**BEFORE THE BOARD OF PATENT APPEALS
AND INTERFERENCES**

Application Number: 10/812,358
Filing Date: March 30, 2004
Appellant(s): KINOSHITA ET AL.

EXAMINER'S ANSWER

Appellants figure 3

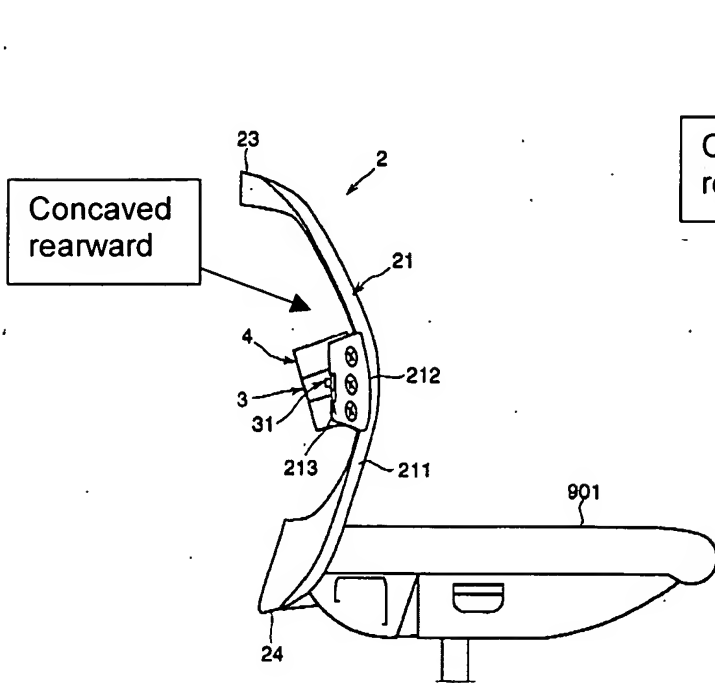
First, Appellant's argues that Sheldon does not anticipate the claim because *the support member is not concaved reward in a top plan view*. However, this limitation is not found in the claims. Claim 1 states, "*wherein the flexible support member bends concaved rearward.*" This does not limit the view in which the support member is concaved rearward. Sheldon meets the limitation that is actually claimed because the support member (22) is concaved rearward in the side view. In fact, Appellants own support member (3) is concaved rearward in the side view. See marked up Figures below.

Further, Appellants seem to argue that the support member (22) in Sheldon is convex forwardly in the side view and is therefore not concaved rearwardly. However, the support member (22) is both since it is shaped like an arc, just like Appellant's. See marked up Figures below.
